**Cancer Treatment Center 2022
South Central Regional Medical Center
Laurel, MS**

Addendum No. 1
September 30, 2022

This addendum forms a part of the contract documents and modifies the original plans and specifications dated June 10, 2022.

AD01

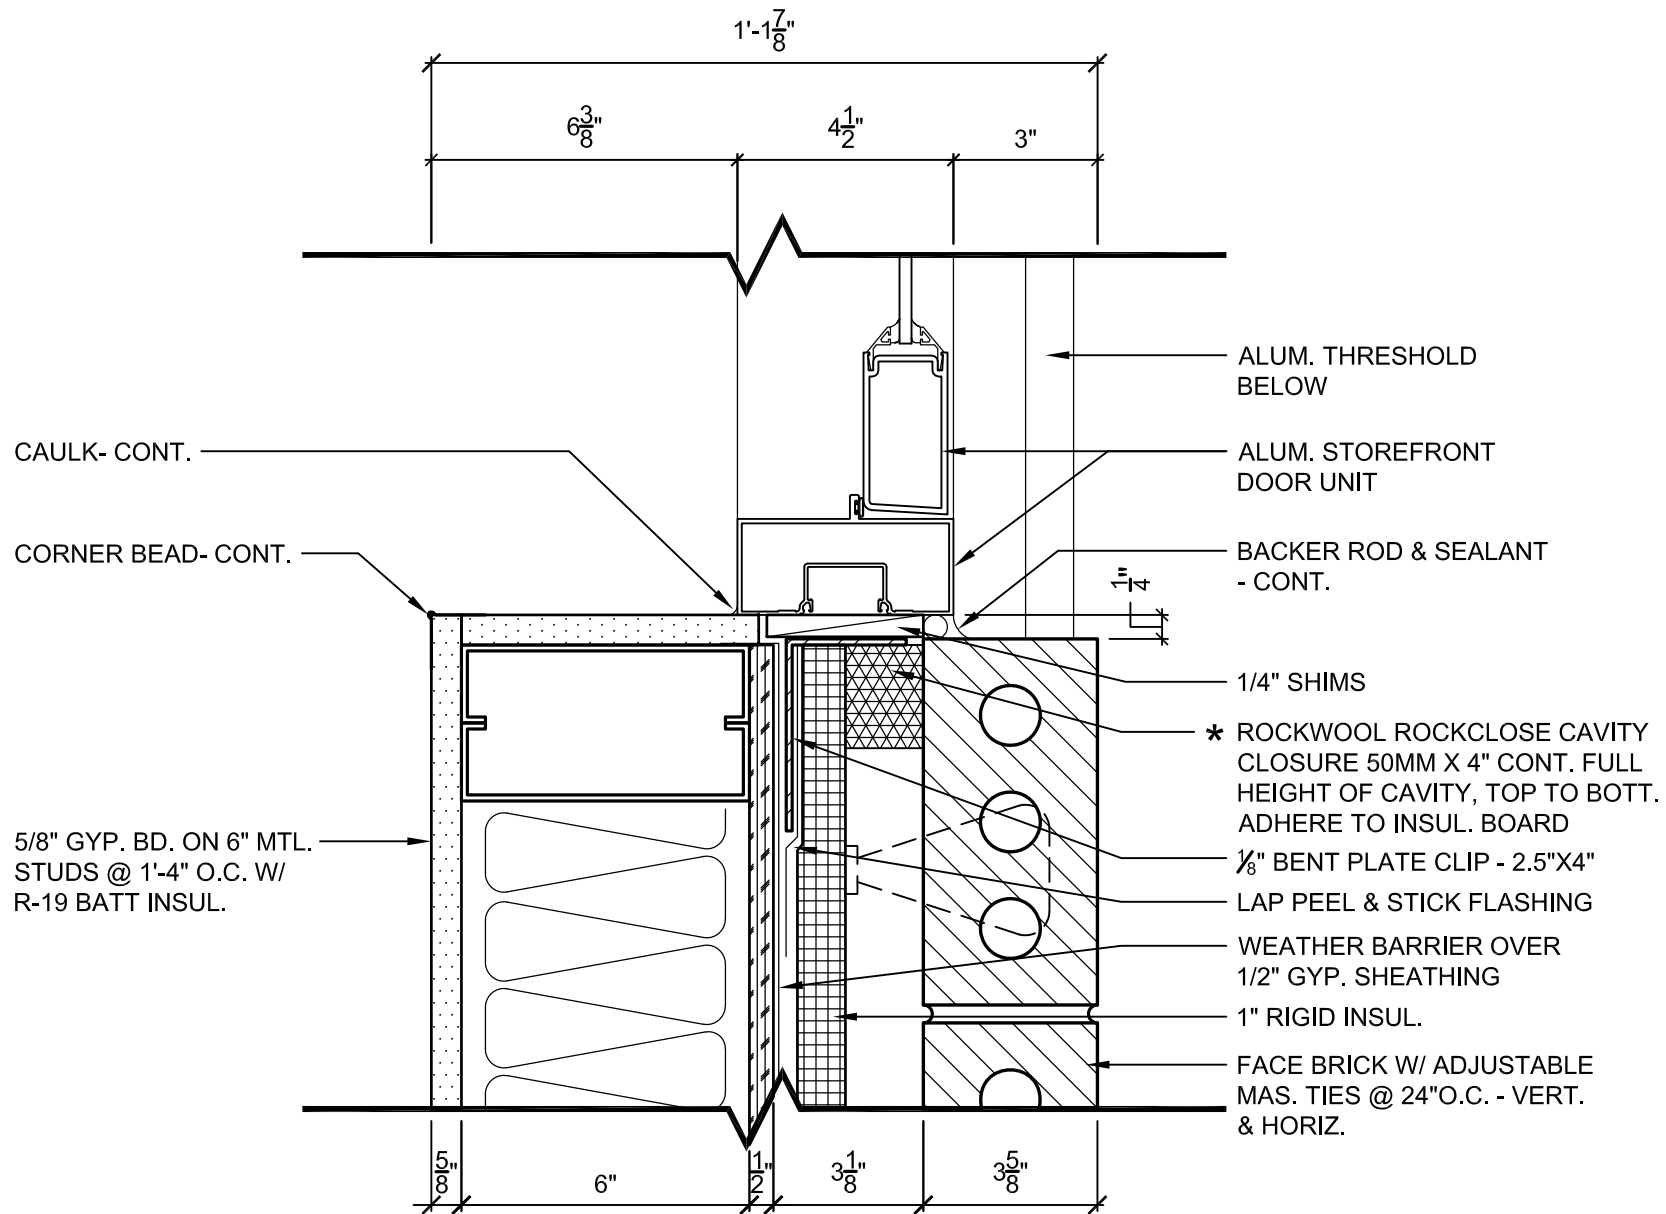
Item 1.3: Sheet A-601, Detail J1

Replace: Detail J1 with attached AD01 which clarifies Flexible Cavity Seal.
